APPLICATION NO.	FILING DATE	FIRST NAMED INVENTOR	ATTORNEY DOCKET NO.	CONFIRMATION NO.
09/886,534	06/20/2001	Nam Mo Ku	ORIEN20.001AUS	6396

Office Action Summary

DETAILED ACTION

ATTACHMENT A

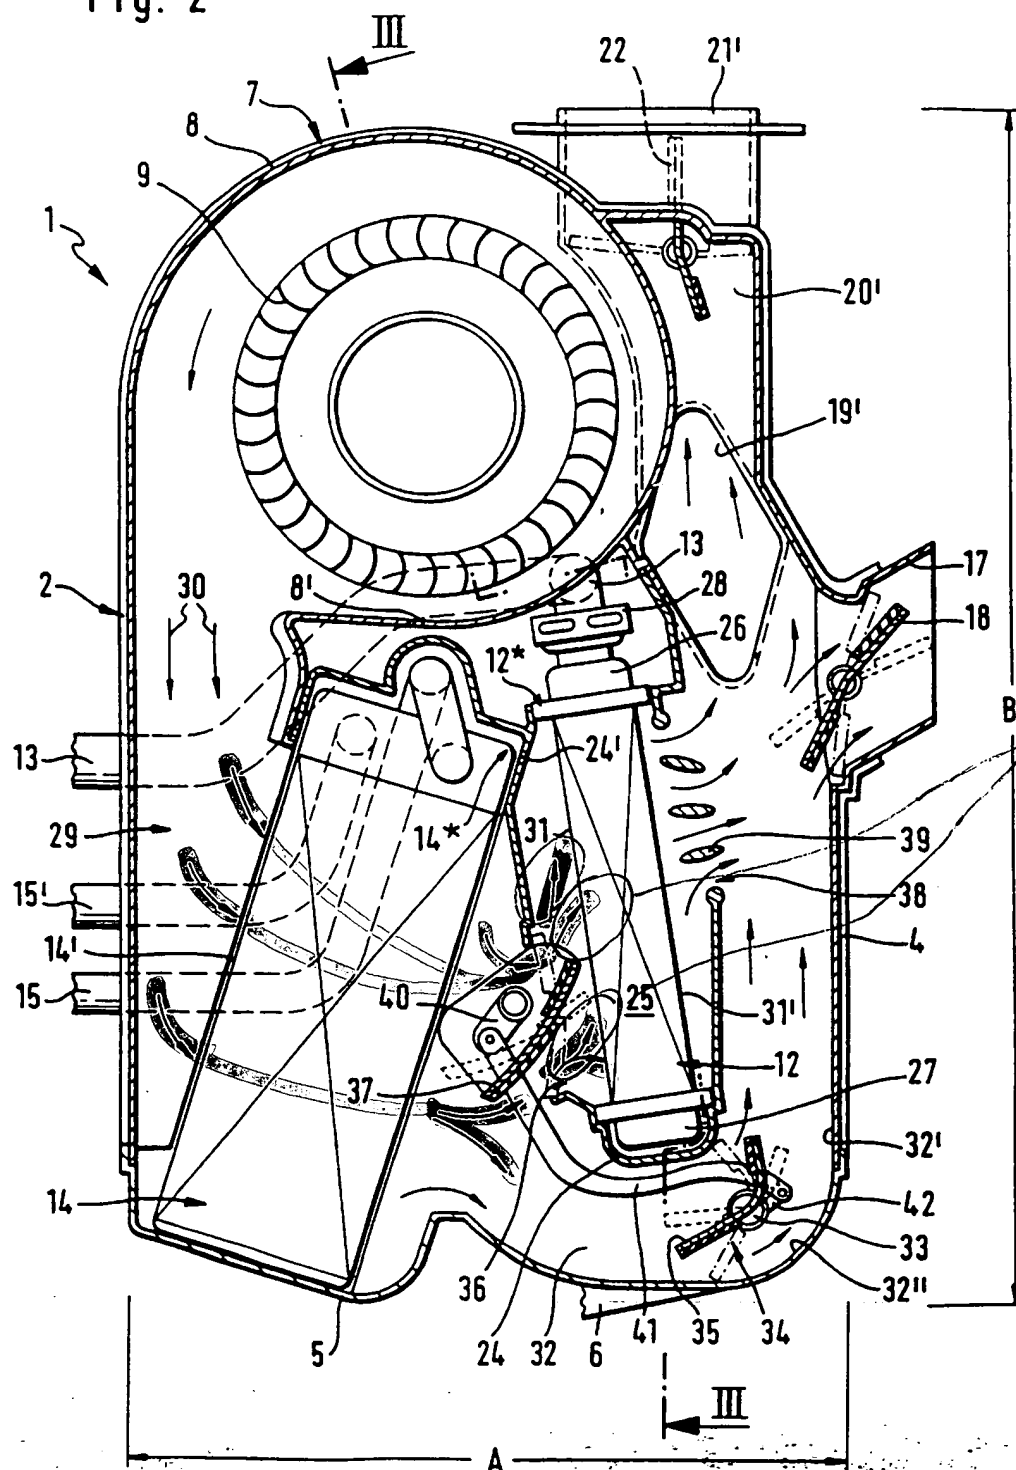
Bendell [especially Figure 2] discloses a vehicular air conditioner 1 essentially as claimed, including, for example: a housing 2 containing three chambers; a first heat exchanger 14 located in the first chamber, wherein the first chamber is configured to pass a first air flow through the first heat exchanger 14 in a first direction as shown by the solid arrows corresponding thereto; a second heat exchanger 12 located in the second chamber, wherein the second chamber is configured to pass a second air flow through the second heat exchanger 12 in a second direction substantially perpendicular to the first direction as shown by at least some the solid arrows

corresponding thereto; a third chamber configured to receive the heat exchanged air from at least one of the first and second chambers and to discharge the same from the air conditioner; a partition member corresponding to inner housing 24 having at least one arcuately curved surface and defining two openings corresponding respectively to the inlet opening 36 between the first and second chambers and to, for example, the inlet of duct passage 32 between the first and third chambers, the partition member or inner housing 24 together with the walls of the housing or casing 2 defining the three chambers, at least a pair of "side" passages configured to allow communication between the second chamber and the third chamber, this pair of "side" passages corresponding to any two of the passages between air-directing elements 39 disposed in the air outlet 39 from the second chamber on the upper side of the second heat exchanger 12 (i.e., hence the passages being "side" passages as broadly interpreted as required); a mix door readable on the combination of control flap 37 as connected to flap body 35 via linkage 41, this combination mix door being thus configured to adjust the degree of opening of both of the first and second openings defined by the partition member or inner housing 24, the door having an arcuately curved surface constituting the arcuate surface of control flap 37, this arcuately curved surface of control flap 37 in turn corresponding to the curved surface of partition member or inner housing 24 at the air inlet opening 36 [see phantom representation of the door or control flap 37 in the closed position as shown in Figure 2]; and, a conduit or connection tube 13 connected to the second heat exchanger 12 through a hole in the wall of the casing or housing 2 defined by the second chamber as shown in Figure 2. Also see Attachment A to this Office action.

at least
these
airflows
are
substantially
perpendicular
to the ones
through
the first
heat
exchanger
14
